Amendments to the Drawings:

REMARKS/ARGUMENTS

File No. 016382-9012

Fig. 10

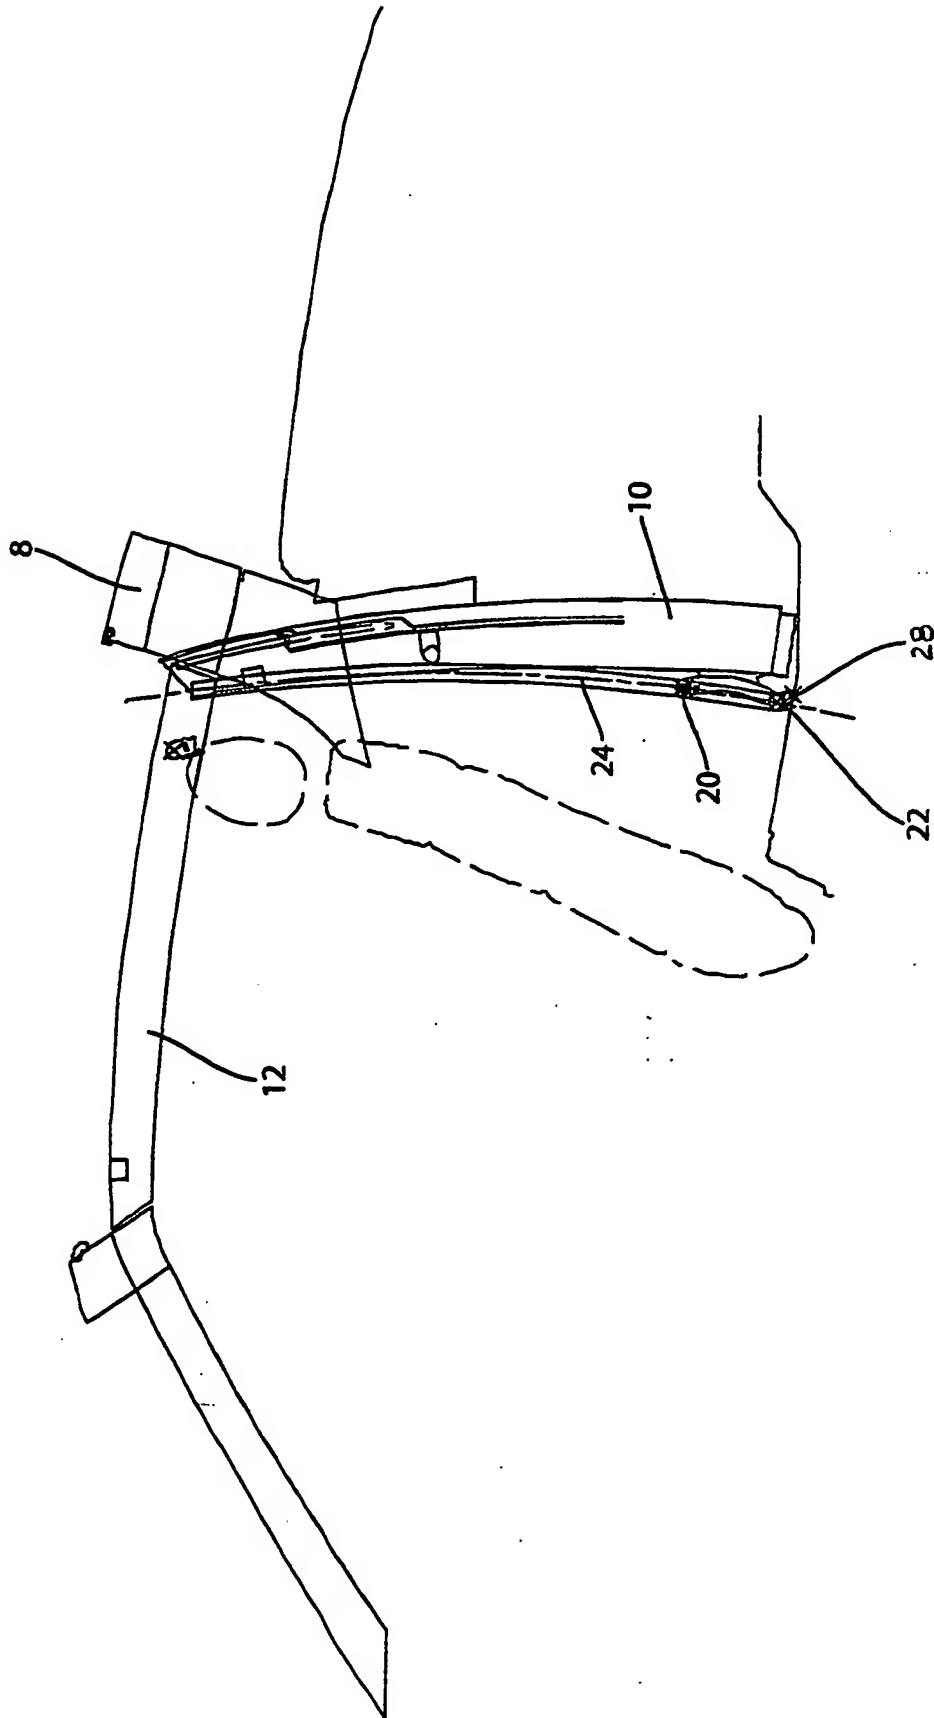
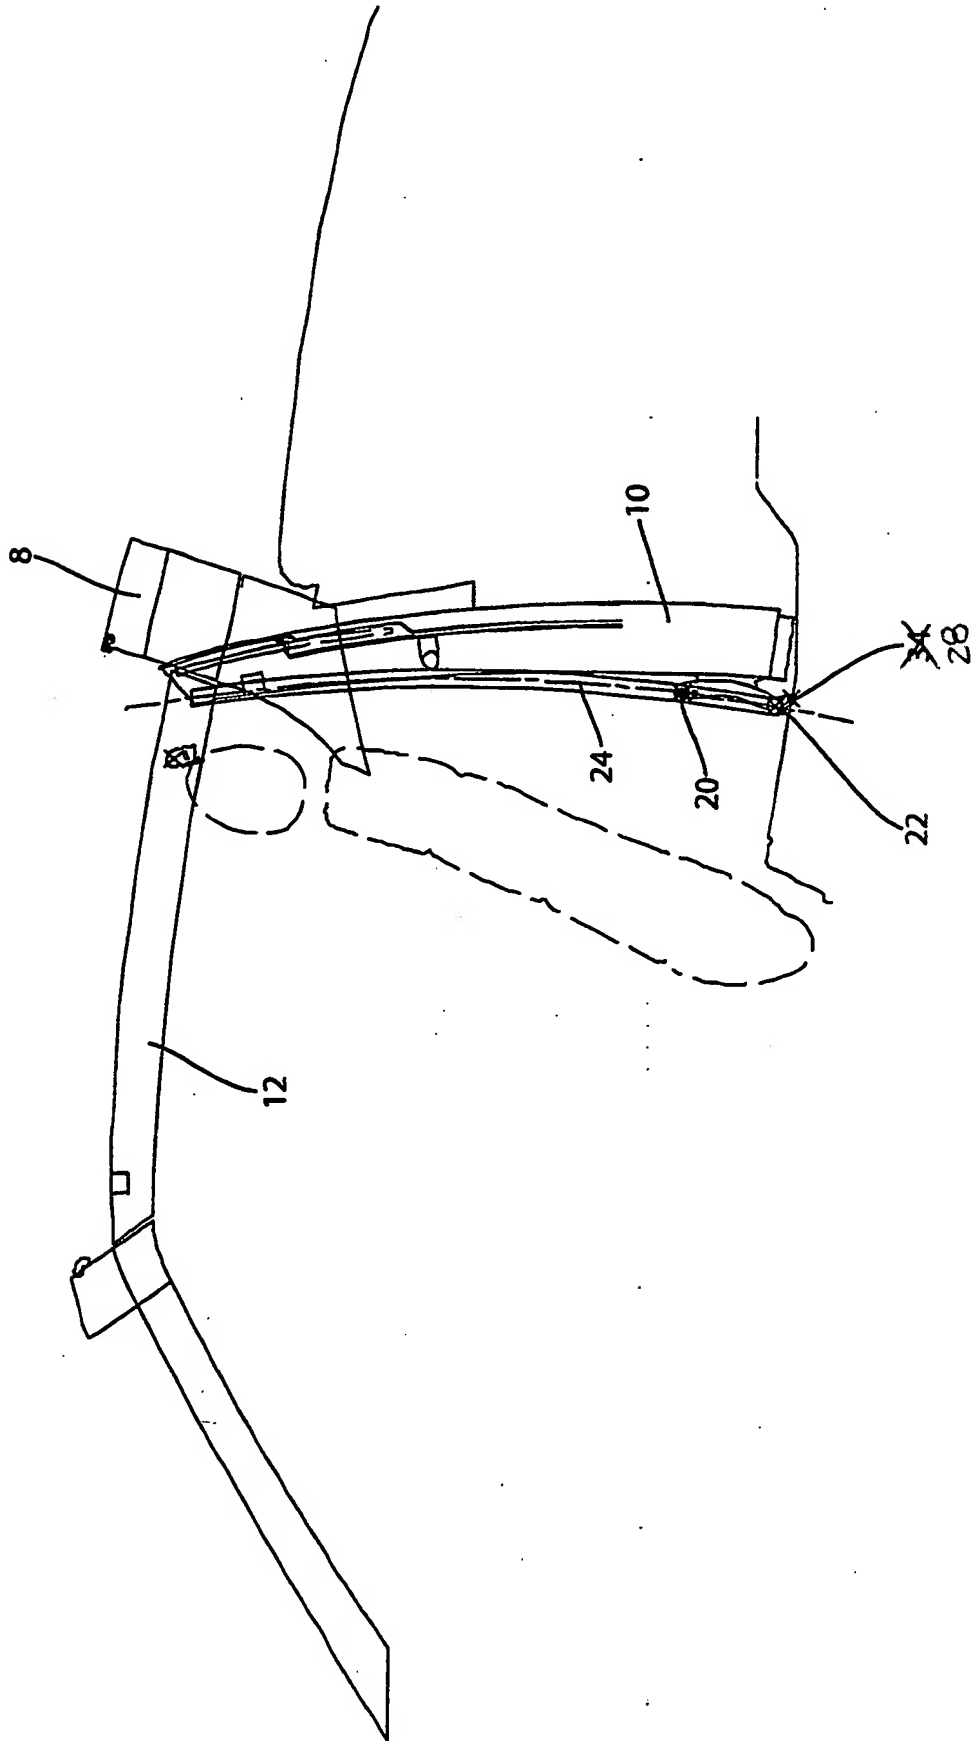
Figures 10 and 11 each have been amended to correct a typographical error by replacing reference number 34 with reference number 28, as was requested in paragraph 4.b. of the Office Action mailed February 5, 2007.

Annotated copies of the amended Figures 10 and 11 are attached hereto to show the sole change made to each of Figures 10 and 11.

Fig. 7

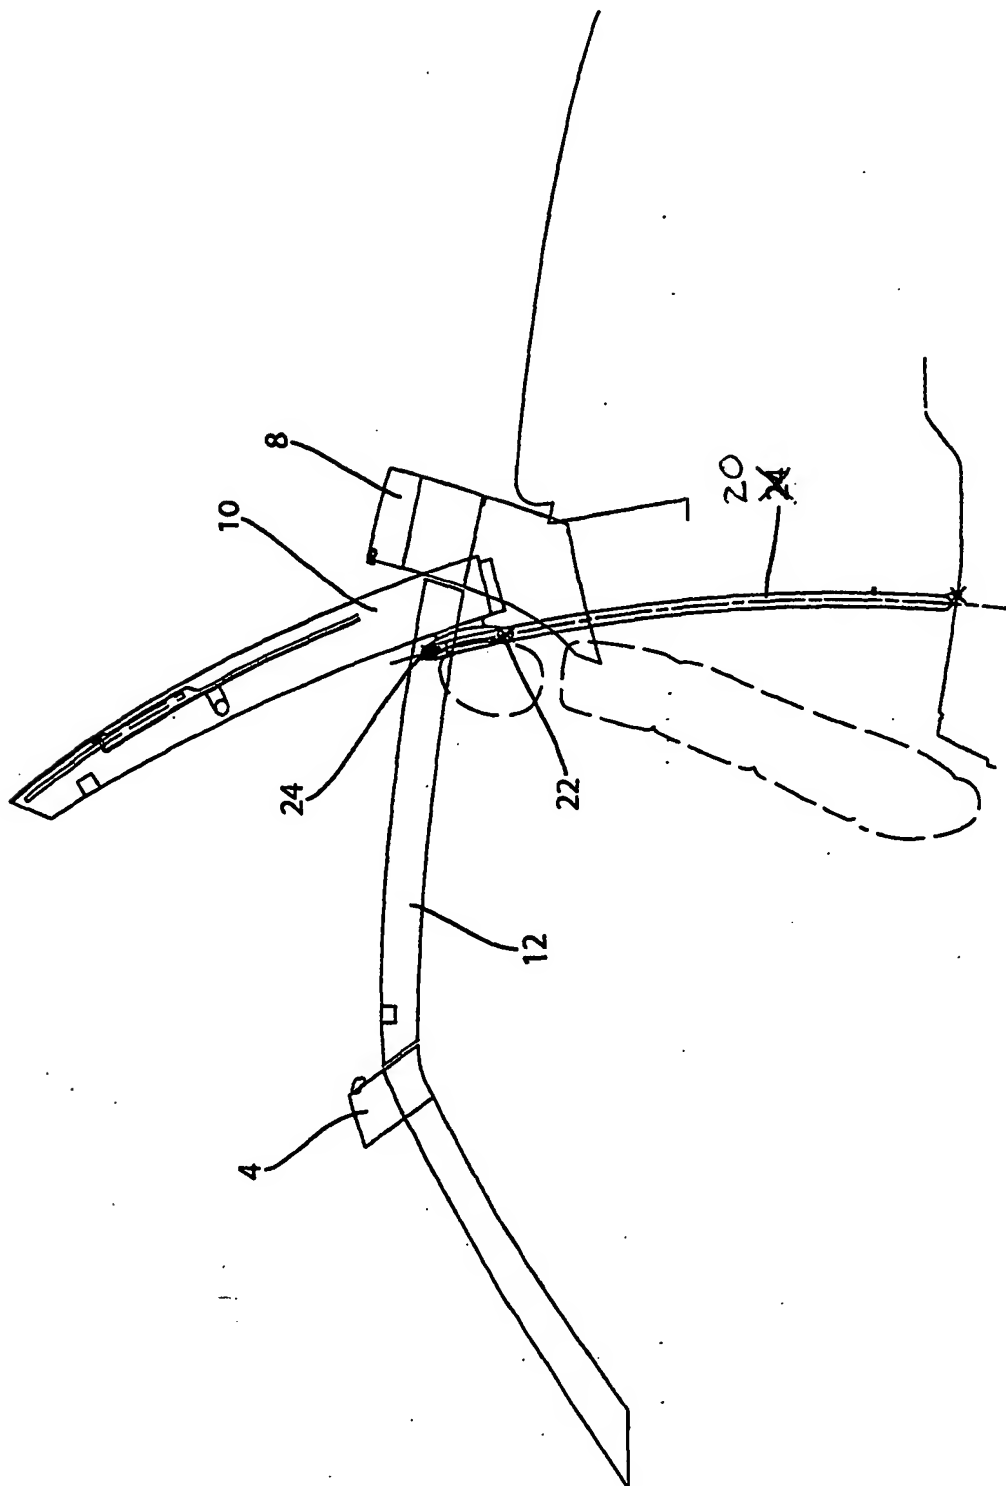
Figure 7 has been amended to correct a typographical error by replacing reference number 24, which is located between reference numbers 4 and 10, with reference number 20, as was requested in paragraph 4.a. of the Office Action mailed February 5, 2007.

An annotated copy of the amended Figure 7 is attached hereto to show the sole change made to Figure 7.
